Project	The Falls on Refugee Road	Addendum Number	3
Project Number	23446	Date	07/10/2025
To	All Bidders

This addendum contains changes to the requirements of the bidding Documents, Project Manual and Construction Drawings which have been issued to date. Such changes are to be incorporated into the Construction Documents and shall apply to the work in the same meaning and force as if they had been included in the original documents. Wherever this Addendum modifies a portion of a paragraph of the Project Manual or a portion of any Drawing, the remainder of the paragraph or Drawing shall remain in force.

E101-A-24217.DWG
PRATER
Engineering Associates, Inc.
6130 Wilcox Road
Dublin, Ohio 43016
DESIGNED BY: N. RUSSELL
DRAWN BY: N. RUSSELL
CHECKED BY: -
JOB NUM: 24217
(614) 766 4896
FAX: (614) 766 2354

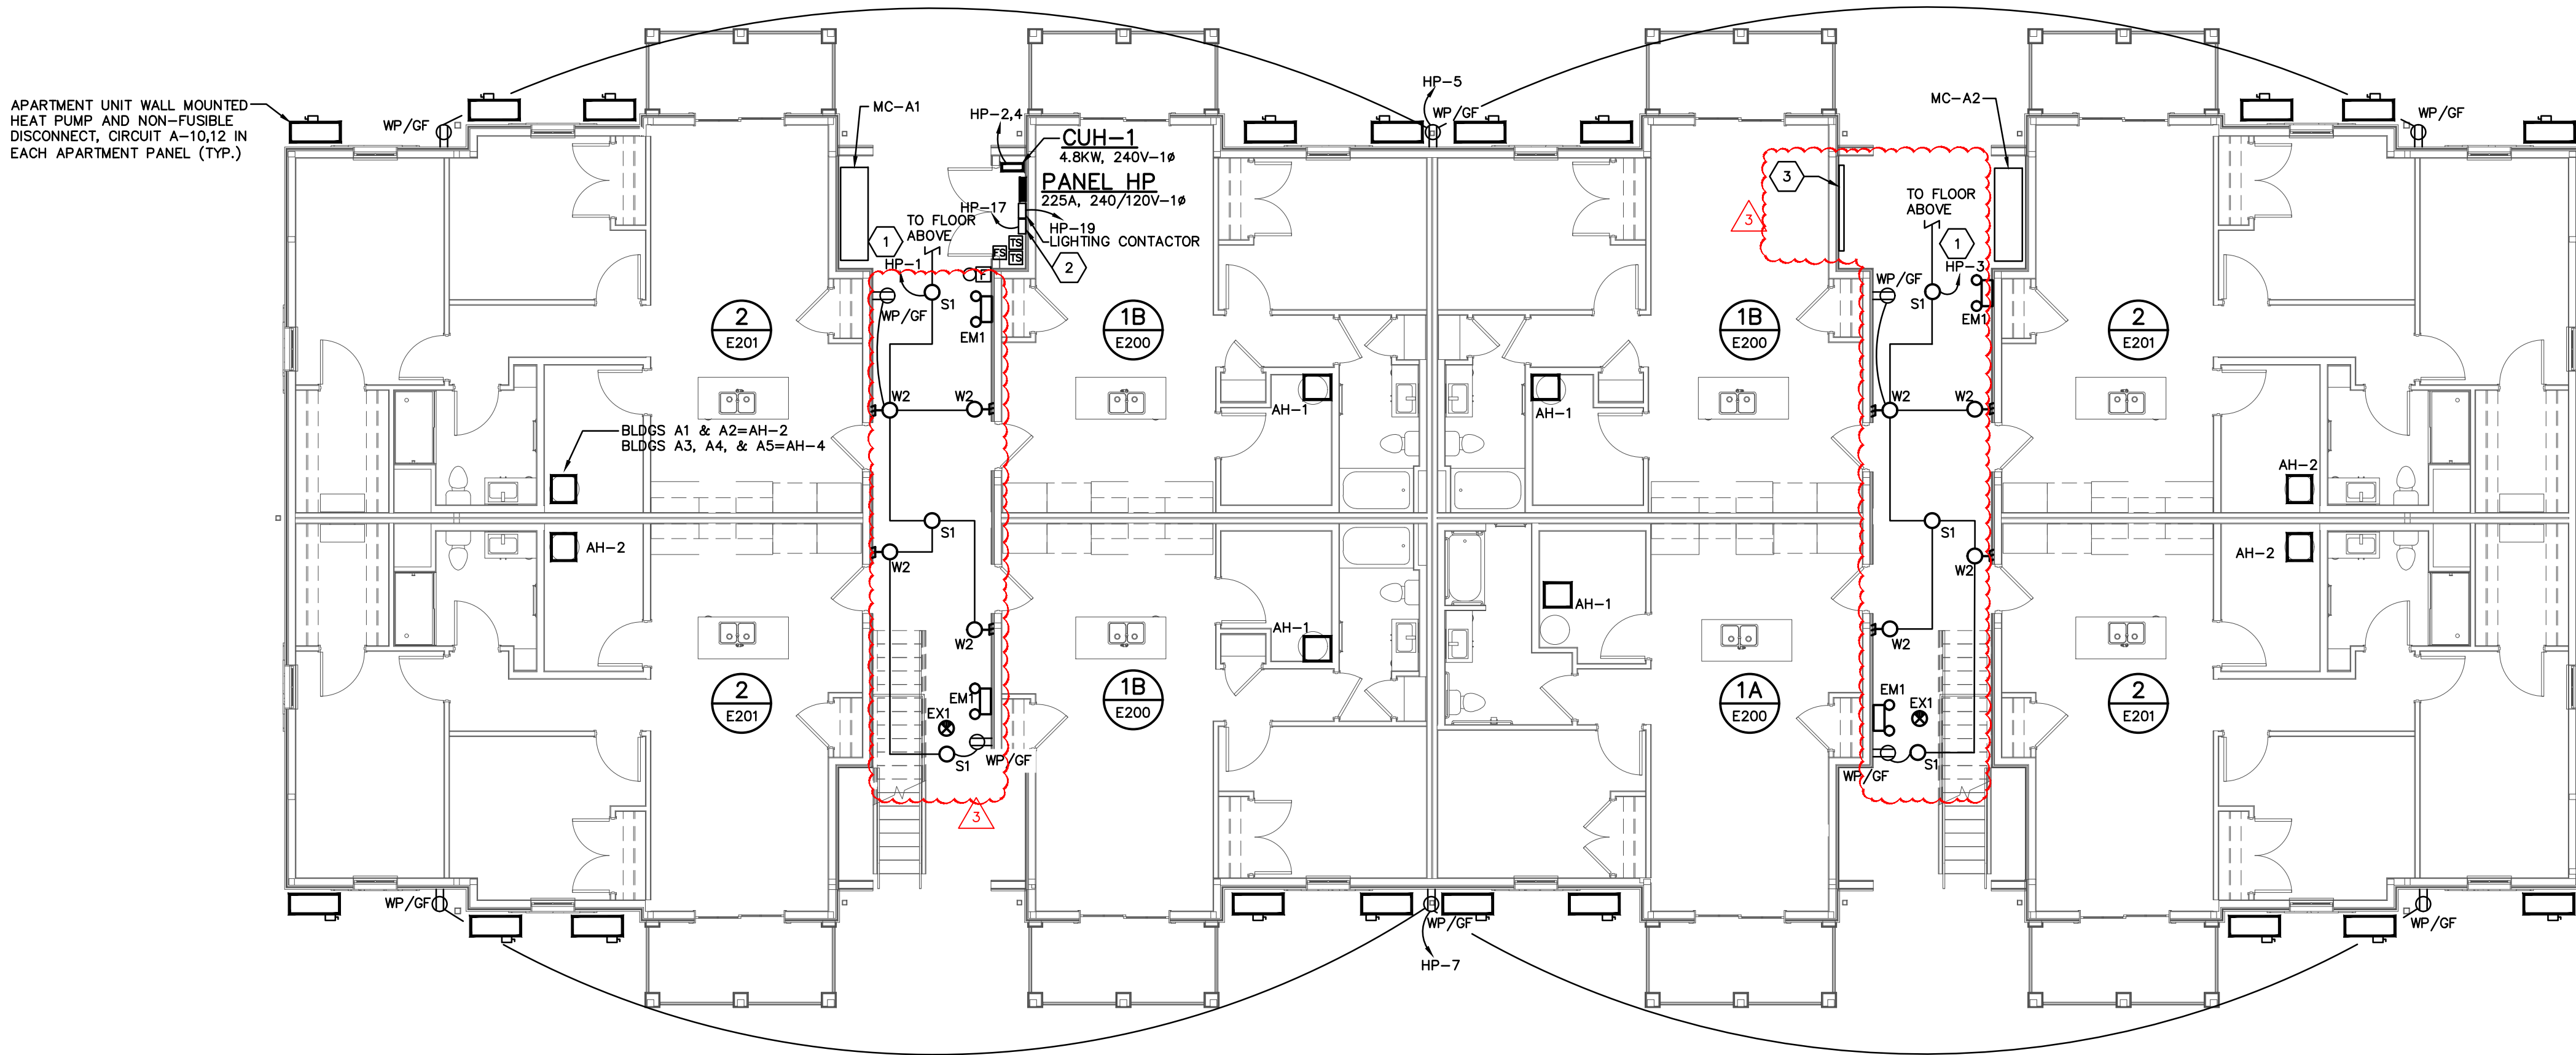
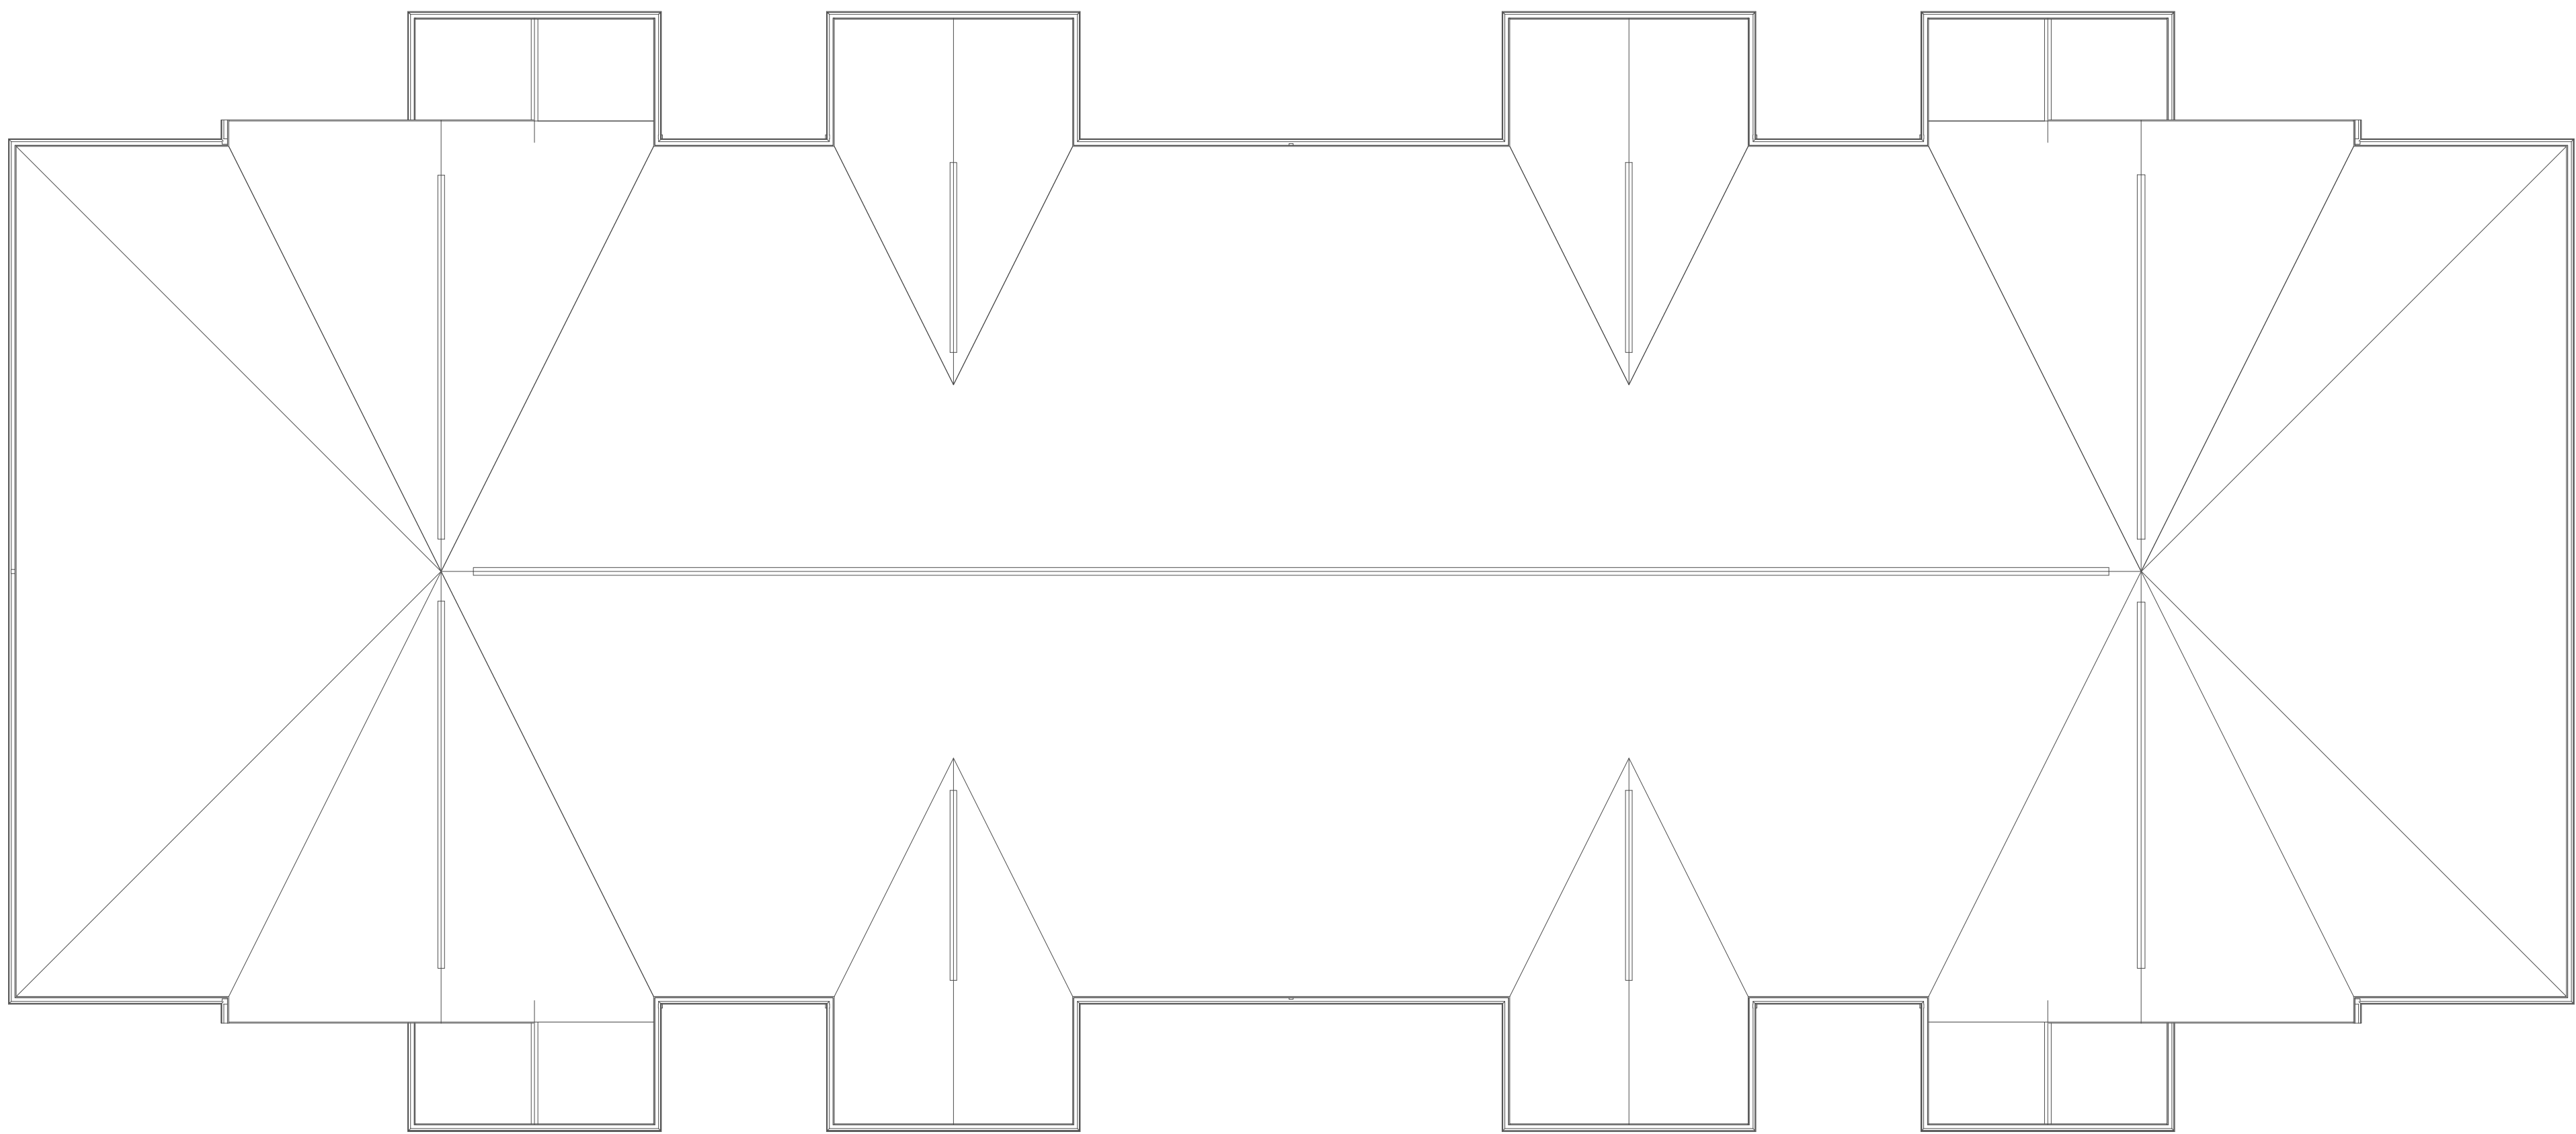
Sheet E101-A, E102-A (Typical of E103-B, E104-B, E105-C, E106-C)

1. Revised locations of S1 fixtures in breezeways.
2. Removed S1 fixtures in upper level breezeways.
3. All W1 fixtures changed to W2 fixtures in the breezeways.
4. Added missing exit sign.
5. Revised exit sign locations on first floor.
6. Moved wall sconce out from under stairway on 1st floor.
7. Added telecom backboard to first floor of breezeway for telecom provider to land their equipment.
